SUBMISSION

NorthConnex SSI 13_6136

Community Against
Polluting Stacks

Figure 1: Portal placement. NorthConnex proposed portal ★ CAPS proposed portal ★

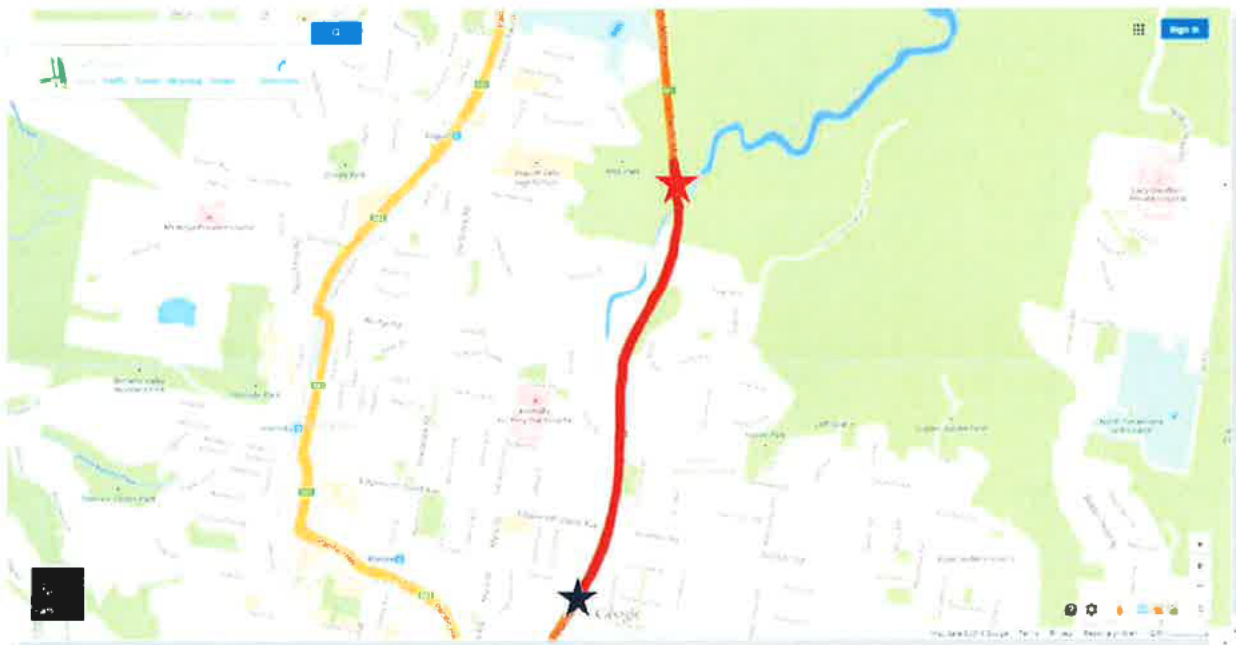
- Portal emissions can adversely impact air quality for about 100-200 metres around them. By locating the M1 exit portal at least 200 metres from residential areas, this will eliminate any potential impacts from portal emissions.
- Portal emissions will occur during emergencies and potentially will involve the uncontrolled discharge of toxic smoke from burning vehicles and tunnel infrastructure into residential areas.
- Portal emissions during normal operations of the tunnel have not been ruled out in the future. If portal emissions are planned during normal operations they need to be moved away from residential areas to protect the communities health.

- Significant reduction in construction impacts including reduced noise, vibration, dust, amenity, traffic and visual impacts.
- Reduction in private property acquisitions.
- No loss in private property values.
- Reduction in visual impacts from surface infrastructure.

Figure 3: Position of CAPS proposed portal ★, with exhaust stack ■ vented into Ku-Ring-Gai National Park

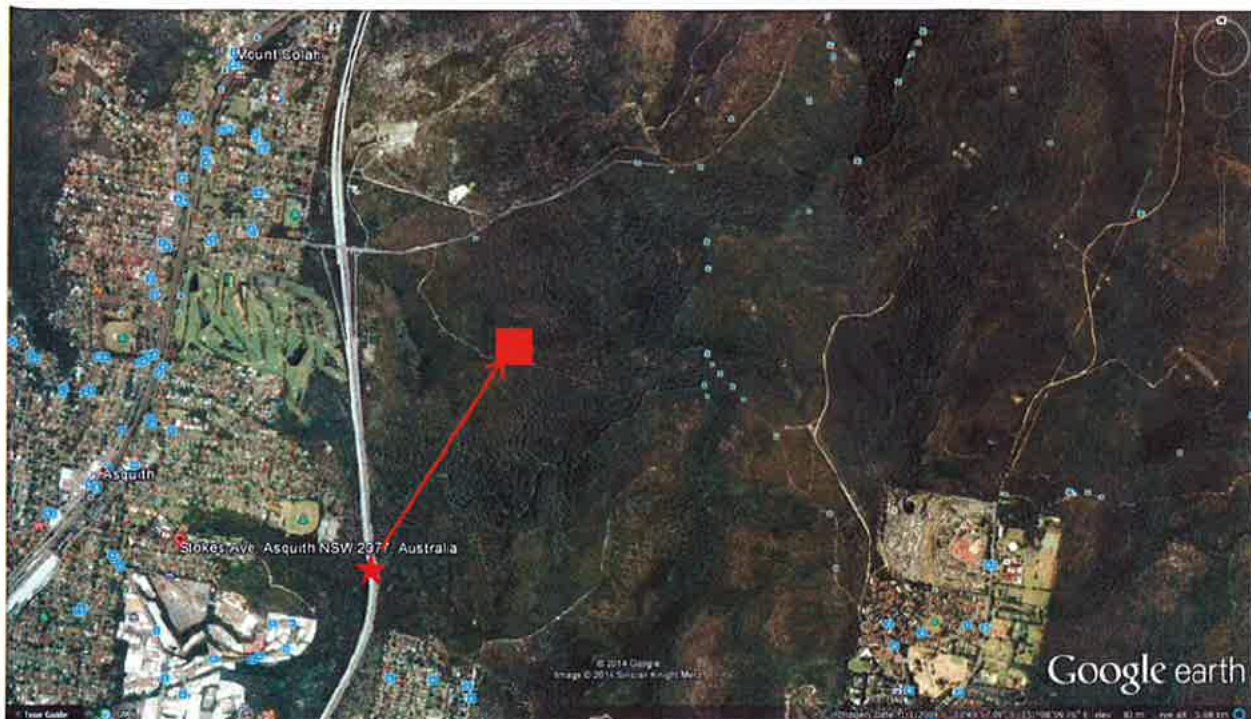
Moving the stack north east of a revised M1 exit portal location to Ku-Ring-Gai Chase National Park would provide a significant buffer to residential areas. Currently there is already a 330kV power line within the National Park and the area of disturbance associated with the stack construction would be substantially lower than a 330 kV power line.

Whilst separating the portal and stack consumes more energy, it does not alter the effectiveness of the tunnel ventilation system. As the stack would be away from residential, this may also allow construction of stack and associated services to continue out of hours.

15.3.5 Zero grade tunnel

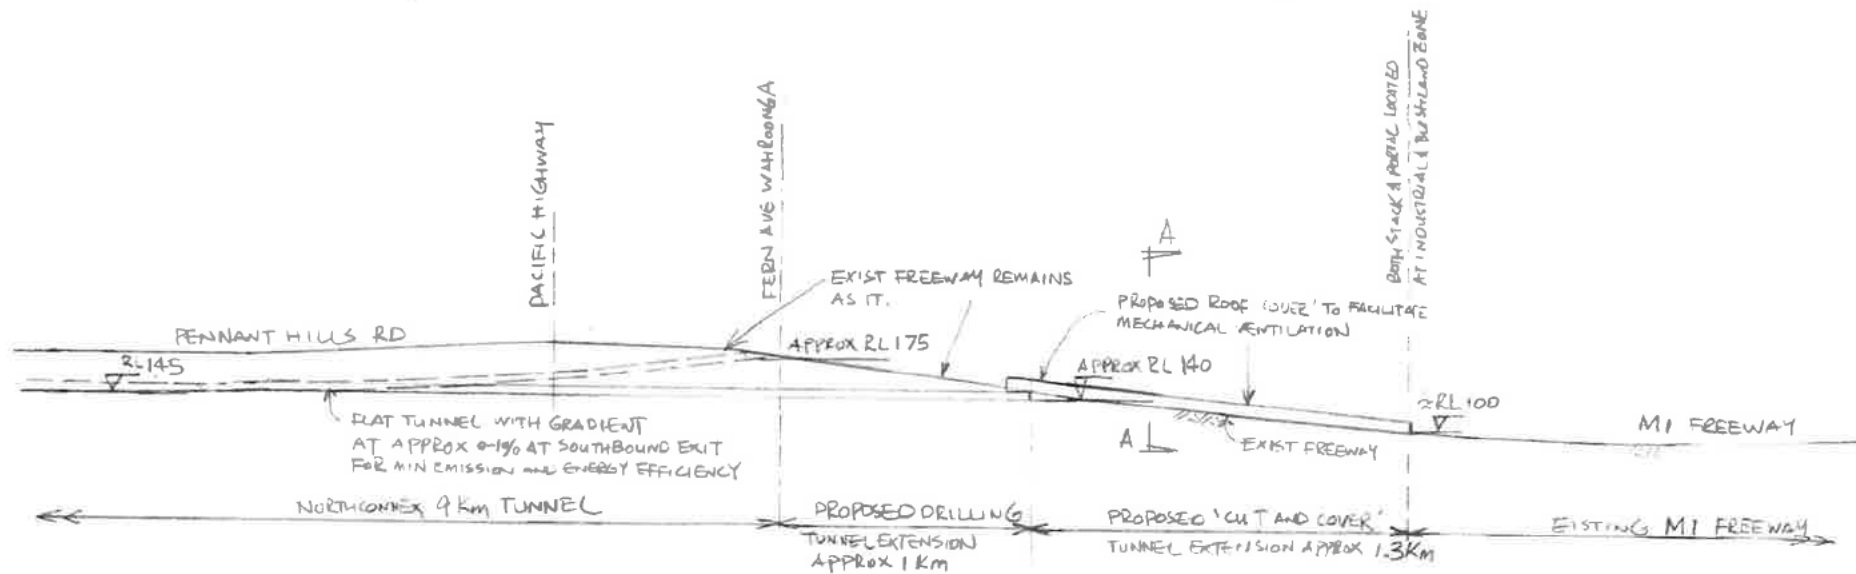
The geological long section of the tunnel presented in Appendix D of the EIS shows that the tunnel from the M2 portals (at about 123 metres RL) dips significantly below the proposed NWRL (to an RL of about 75m) before rising to about RL 175 at the M1 portals in Wahroonga. Because of this significant sag in the tunnel, both southbound and northbound vehicles experience high road grades – which result in the generation of significantly higher quantities of pollutants.

A much better solution would be to reduce the grade to as close to zero as possible. While this is not possible with the M1 portals being located in Wahroonga, however, if the portals were located on the M1 in line with Stokes Avenue in Asquith (which is about RL 121 metres), a zero grade tunnel at approximately 120 metres RL becomes a closer reality. The only issue is the interface with the NWRL and a low point just north of the M2. A more complex tunnel alignment and construction methodology would be required in this area (with NorthConnex going over the NWRL slot rather than under), however, there is no technical reason why this could be achieved. As the NWRL would not be an operational rail line (and NWRL tunneling may not have even reached this location by the time NorthConnex starts tunnel construction), the construction and safety risks are significantly reduced.

ALTERNATIVE 'CAPS' PROPOSAL FOR 'CUT & COVER'
TUNNEL EXTENSION AT WAHROONGA
AT 21/8/14

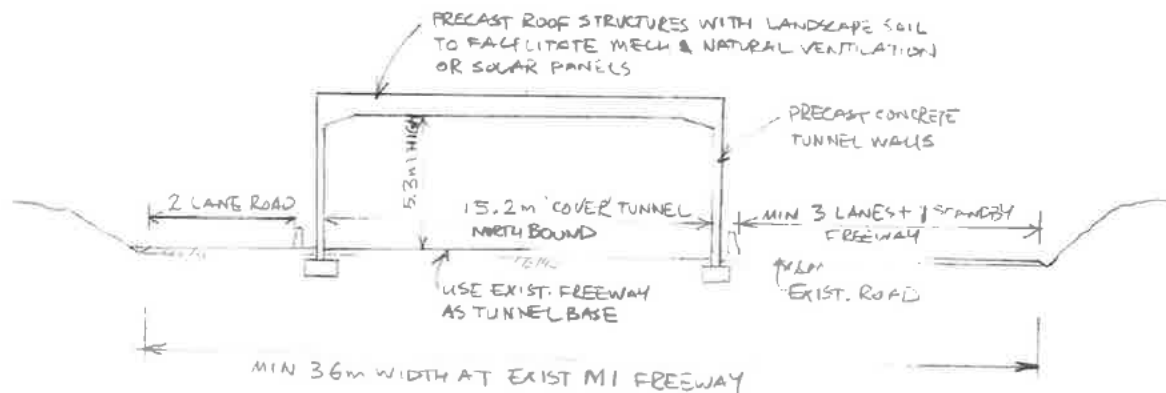
Another alternative to extend the tunnel further north would be to cover the existing M1 with a concrete structure. Basically once the tunnel reaches RL 140 metres instead of continuing to tunnel up to RL170 metres at Woonona Ave, a flat tunnel would be constructed which would exit about 1 kilometre north of the currently proposed M1 exit portal location. For another kilometre the tunnel could be extended using an above ground concrete tunnel. The cost of this type of construction would be significant lower than underground tunneling (about 75% lower) – and appropriate safety and egress requirements could be easily implemented. A diagram showing the concept is presented on the following page.
